Transport Statement

**Proposed Residential Development
Land East of Leicester Road
Earl Shilton**

Report Reference: 923-TS-01-0

Designer's Response
MAC report ref 923-TN-01-0

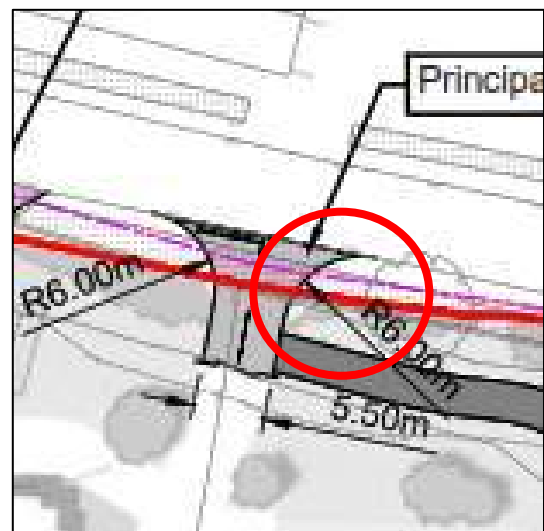
Summary: Risk of overshoot type collisions

There is a level difference the site and the unnamed road. This could result in a steep downhill gradient towards the junction for drivers emerging from the development which may lead to loss of control or overshoot type collisions, particularly during wet or icy conditions.

It is recommended that the gradient of the access should not exceed 4% over a distance of at least 15 metres from its interface with the unnamed road to provide a relatively flat section on the approach to the give-way.

Accepted. Minimum gradients will be used over the first 15m, measured from behind the give-way line, to ensure a flat section on the approach to the give-way position. This design parameter will be reviewed further at the detailed design stage with the Local Highway Authority to ensure approval.

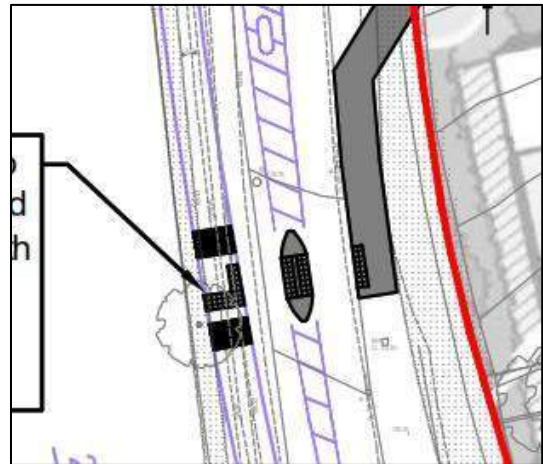
Summary: Increased risk of vehicle to
pedestrian collisions during the
hours of darkness.

The pedestrian crossing point is located on an unlit section of Leicester Road. During the hours of darkness any pedestrian crossing or waiting to cross will not be visible to approaching vehicles. This may lead to a pedestrian being hit and injured.

It is recommended that the existing street lighting is extended to cover the proposed pedestrian crossing so that a person or cyclists waiting to cross are effectively illuminated during the hours of darkness.

Accepted.

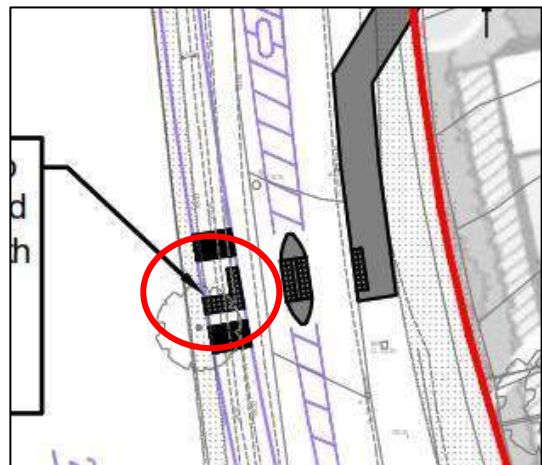
Summary: Narrow crossing facility may lead to rider injury

The proposed refuge island is narrow for cyclists to use safely. Cyclists may be susceptible to being struck by passing vehicles as they are likely to need to overhang into the carriageway when waiting on the island.

It is recommended that the refuge island width should be increased to a minimum of 3m.

Accepted. The proposed refuge island has been relocated slightly to the north, where a 3m deep facility can be provided within the ghost island hatching. See MAC drawing 923-TA10B included in **Appendix C**, for further details.

APPENDIX B: Drawing Showing Problem Locations

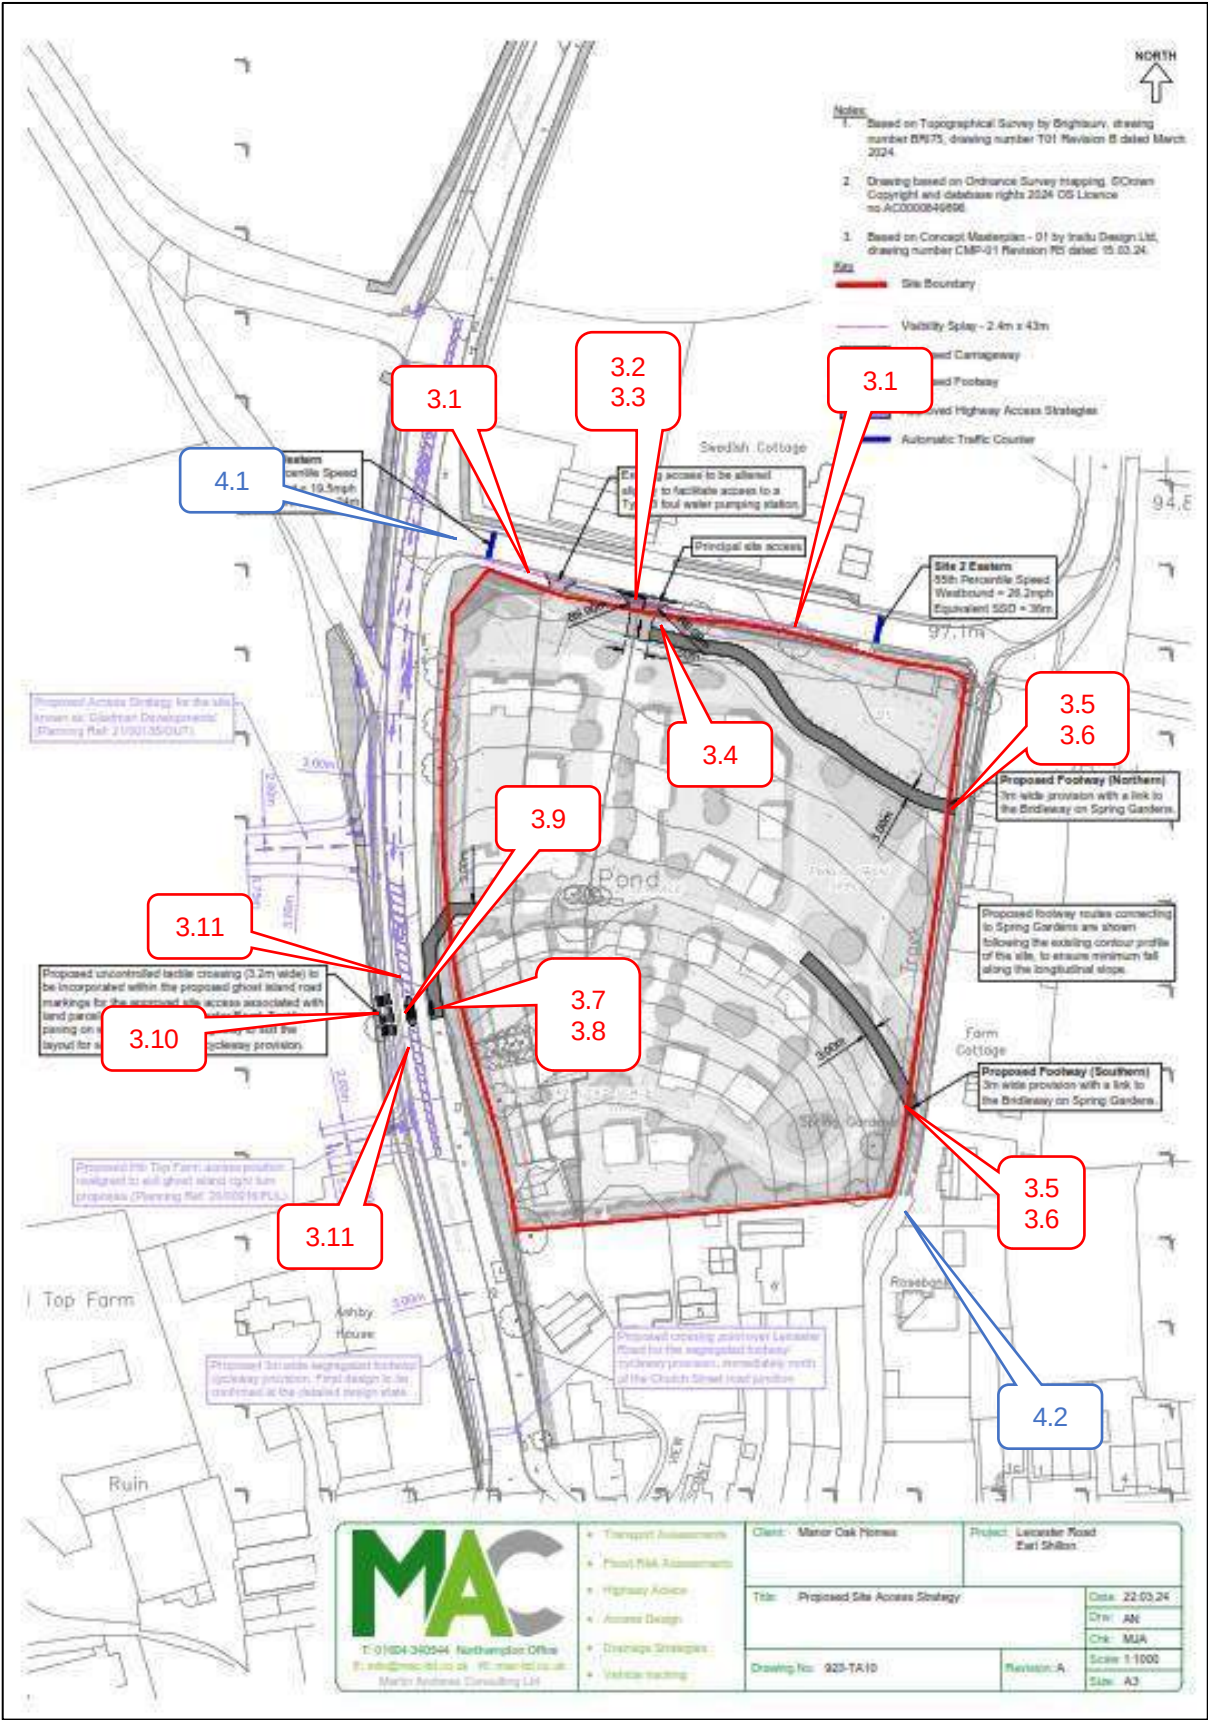
-
- 1.8. The Road Safety Audit is not a technical check that the design conforms to Standards and/or best practice guidance. Design Organisations are responsible for ensuring that their designs have been subjected to the appropriate design reviews (including, where applicable, Non-Motorised User (NMTU) Audits) prior to Road Safety Audit.
 - 1.9. All comments and recommendations are referenced to the design drawing and the locations have been indicated on plans in Appendix B .

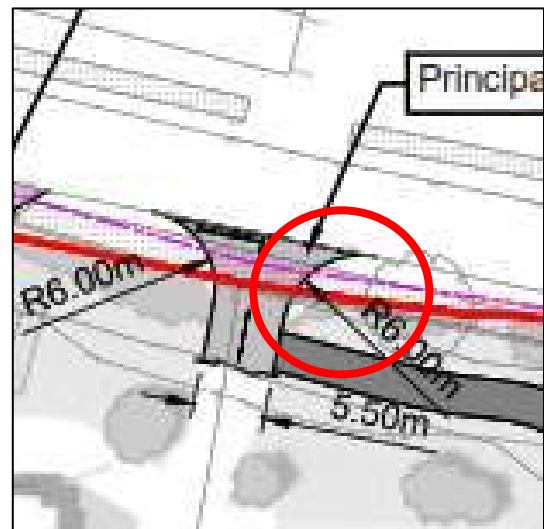
Summary: Risk of overshoot type collisions

There is a level difference between the site and the unnamed road. This could result in a steep downhill gradient towards the junction for drivers emerging from the development which may lead to loss of control or overshoot type collisions, particularly during wet or icy conditions.

It is recommended that the gradient of the access should not exceed 4% over a distance of at least 15 metres from its interface with the unnamed road, to provide a relatively flat section on the approach to the give-way.

APPENDIX B: Drawing Showing Problem Locations

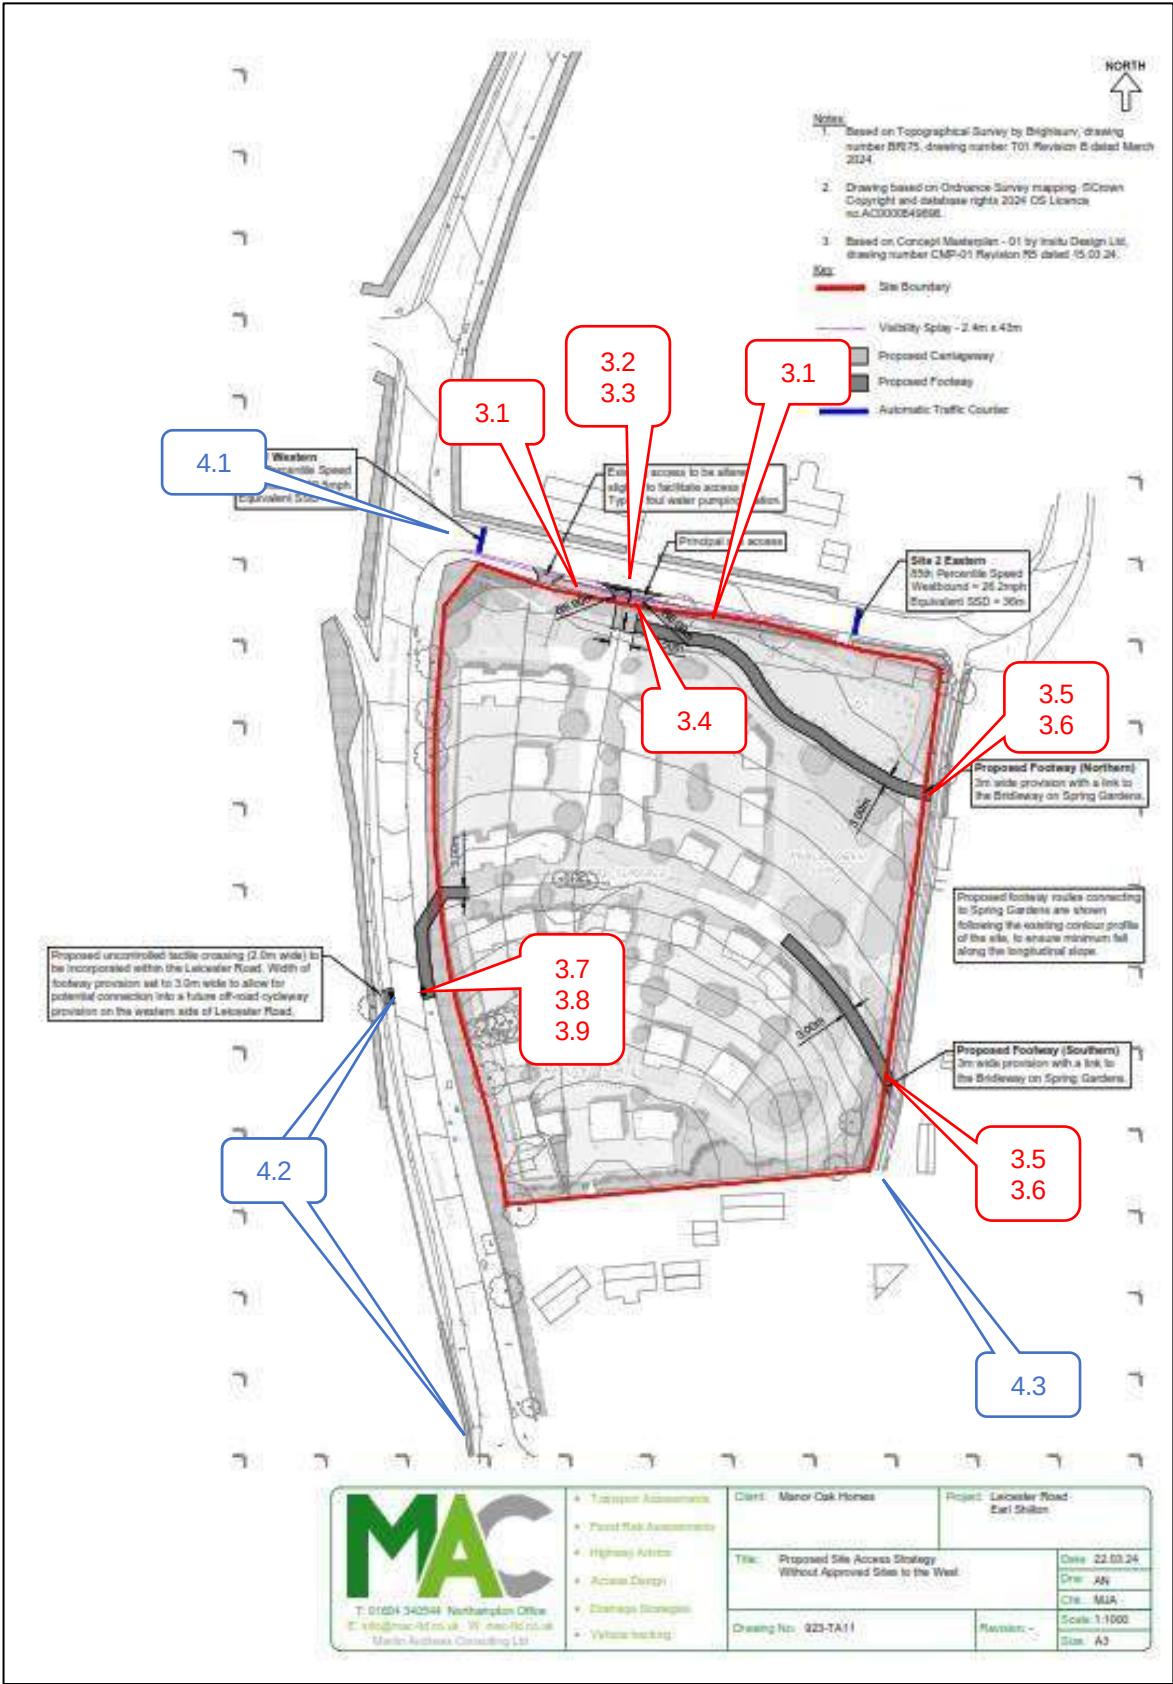
-
- 1.8. The Road Safety Audit is not a technical check that the design conforms to Standards and/or best practice guidance. Design Organisations are responsible for ensuring that their designs have been subjected to the appropriate design reviews (including, where applicable, Non-Motorised User (NMTU) Audits) prior to Road Safety Audit.
 - 1.9. All comments and recommendations are referenced to the design drawing and the locations have been indicated on plans in Appendix B .

Proposed Access Strategy
MAC drawing number 923-TA10B

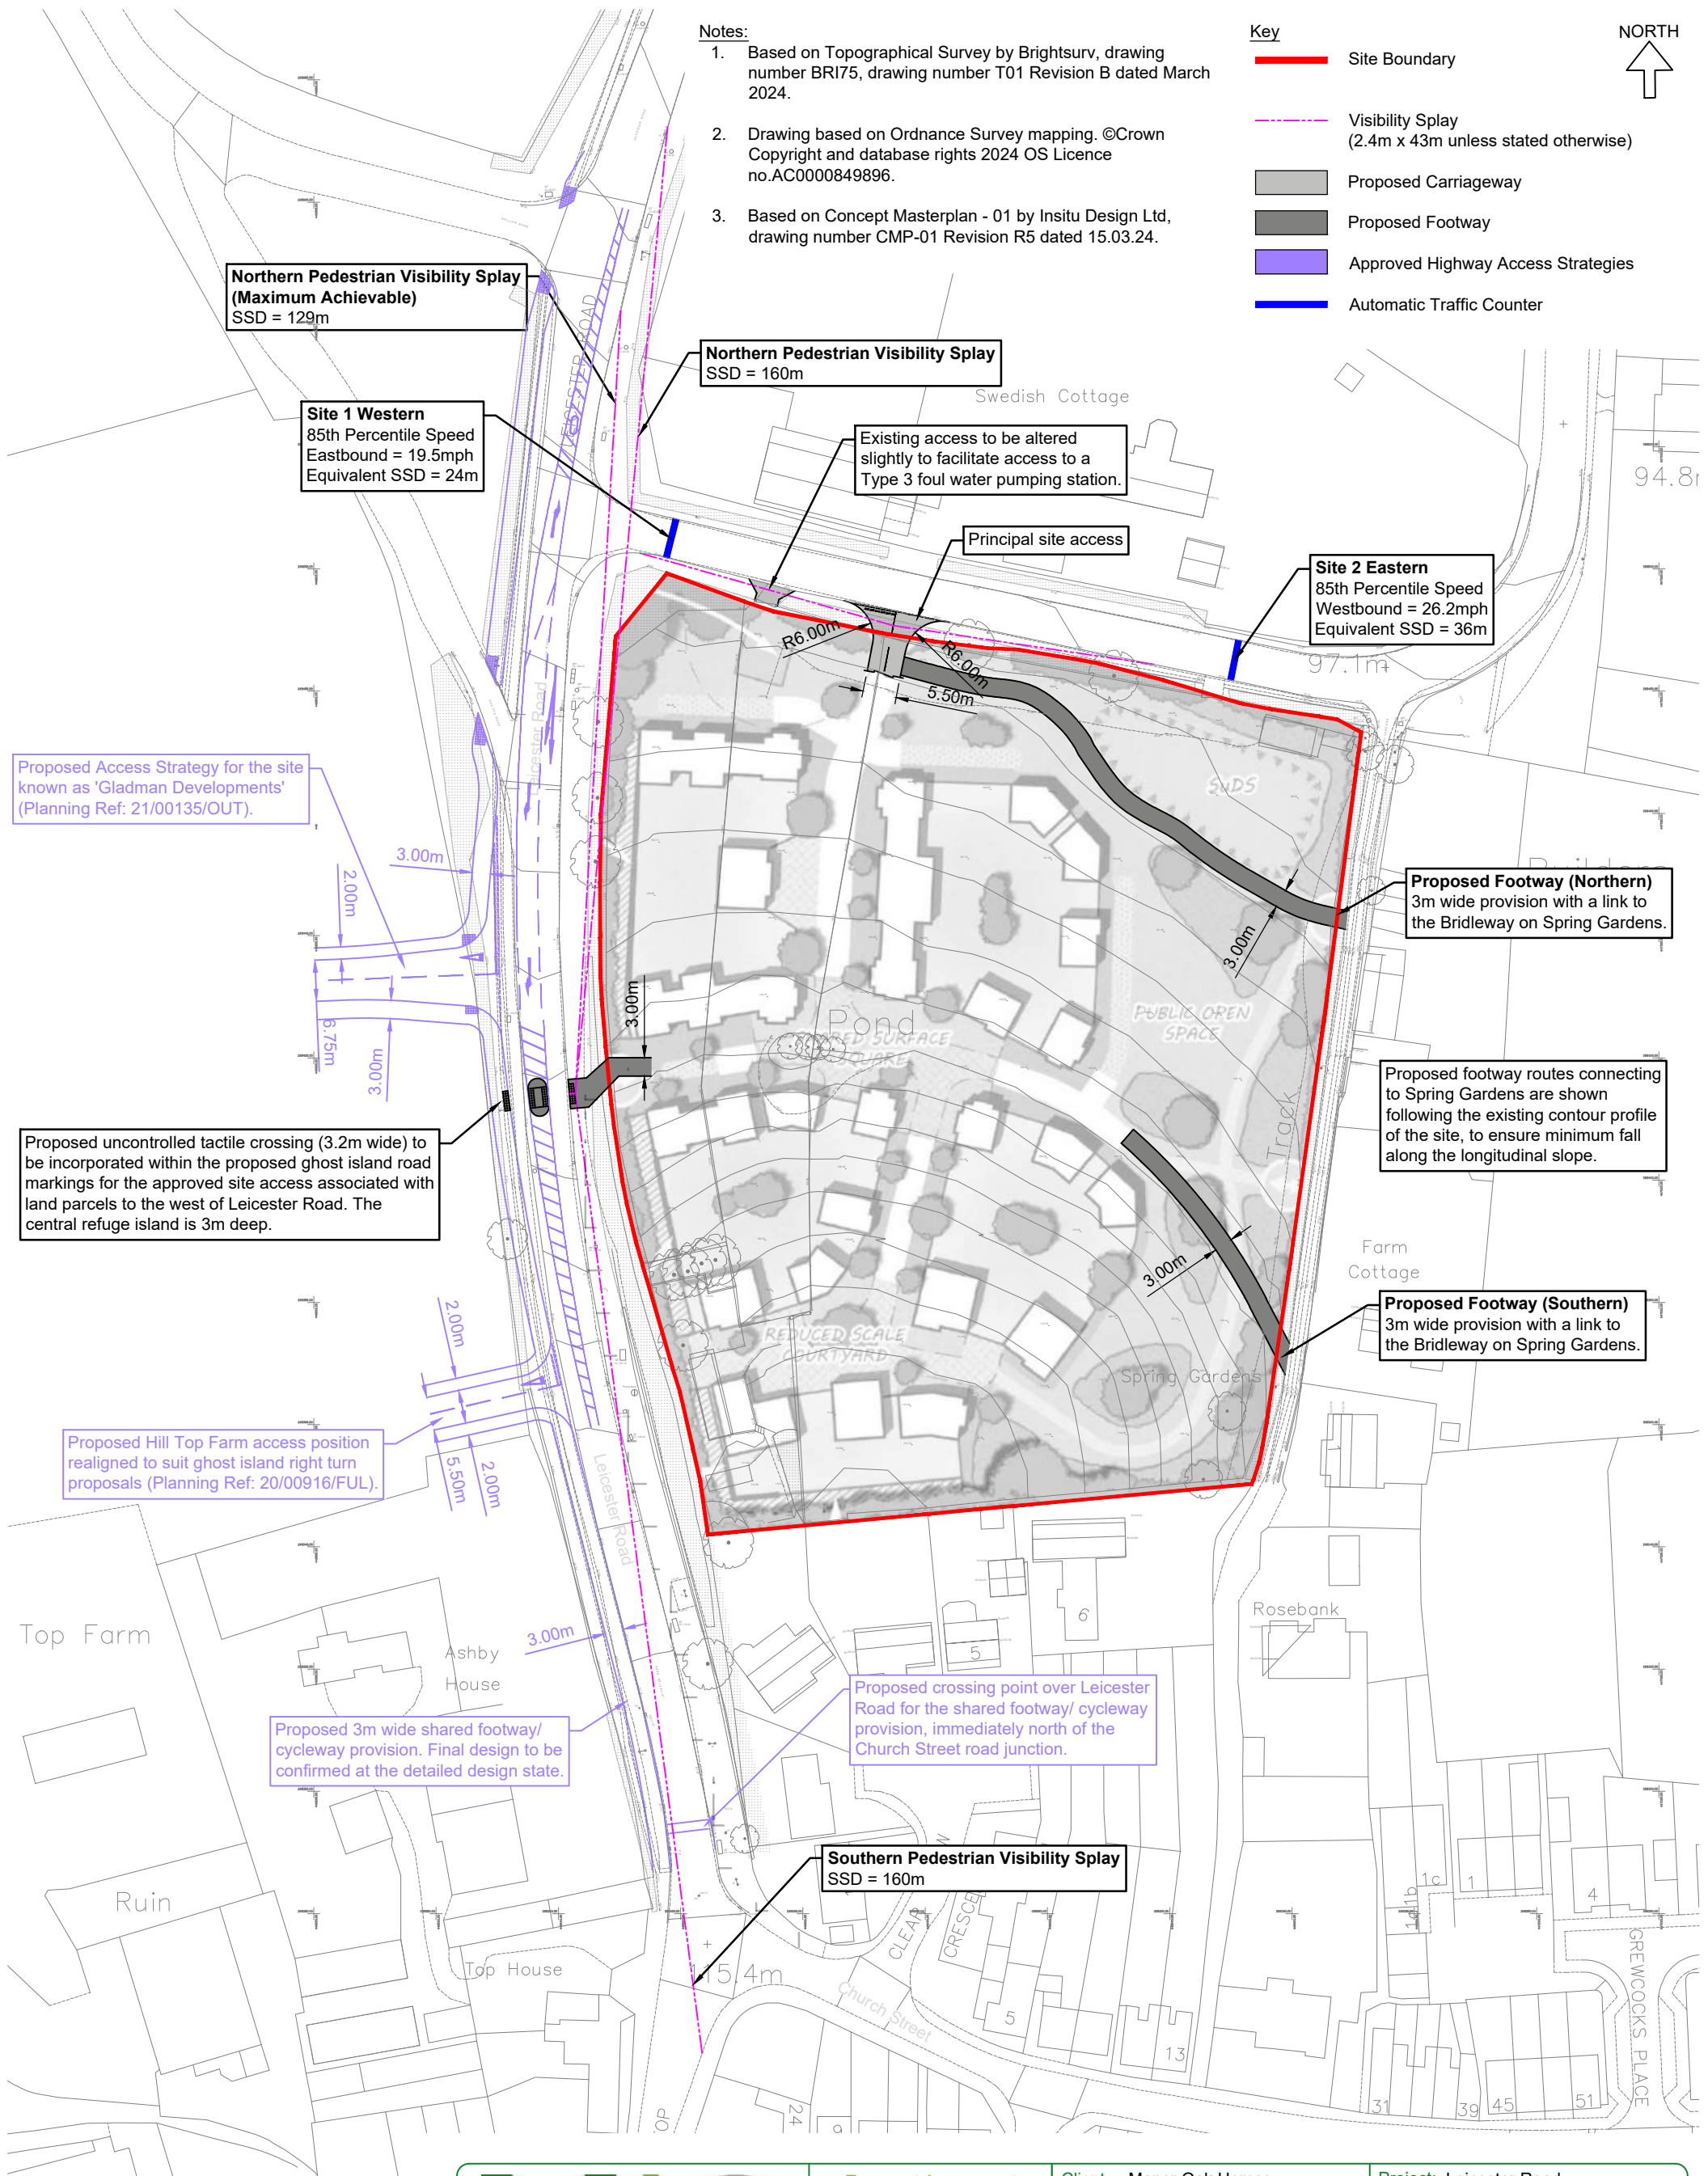
- 2.14 The pedestrian crossing point is located on the section of Leicester Road which is subject to a 50mph speed limit. Visibility for and of persons crossing from the eastern side of Leicester Road may be restricted by the curvature of the road and vegetation in the verge. Insufficient visibility could result in pedestrians inadvertently stepping out into a path of a vehicle being hit and injured.

It is recommended that appropriate visibility splays are provided to and at the crossing consistent with measured free flow 85th percentile vehicle speeds. If adequate visibility cannot be provided measures should be implemented to reduce driver/rider speeds to match the available visibility splay and to provide adequate warning of the potential for pedestrians to be crossing the carriageway ahead.

- 2.18 The proposed refuge island is narrow for cyclists to use safely. Cyclists may be susceptible to being struck by passing vehicles as they are likely to need to overhang into the carriageway when waiting on the island.

It is recommended that the refuge island width should be increased to a minimum of 3m.

- 2.20 The layout of the tactile paving at the uncontrolled crossing on the western side is not in accordance with the DfT Guidance on the use of Tactile Paving Surfacing. For uncontrolled crossings the tactile paving should not have a stem. The use of 'L shaped tactile paving may confuse sight impaired pedestrians who may think it is a controlled crossing.

It is recommended that the correct tactile paving layout arrangement should be used, refer to the DfT 'Guidance on the use of Tactile Paving Surfaces'.

- 2.22 On the approach sides of the pedestrian refuge island, the hatched road markings, when projected forward, appear to line up with the kerbs. In poor weather, some drivers may take their alignment from the offside line markings. This may lead to kerb strikes and loss of control type collisions.

It is recommended that road markings should be offset from the kerb lines to ensure drivers are guided away from the pedestrian refuge island. Ref: Traffic Signs Manual Chapter 5 para 2.8.2.

MAC drawing number 923-TA10B included in **Appendix C**, has been amended to show the 1m x 160m stopping sight distance visibility splay at the proposed crossing location.

Accepted. The proposed tactile crossing arrangement has been amended to remove the L shaped crossing previously illustrated. See MAC drawing 923-TA10B included in **Appendix C**, for further details.

Accepted. The proposed refuge island has been relocated slightly to the north, so that it is fully accommodated within the hatched road markings, with an offset to the kerb lines. See MAC drawing 923-TA10B included in **Appendix C**, for further details.
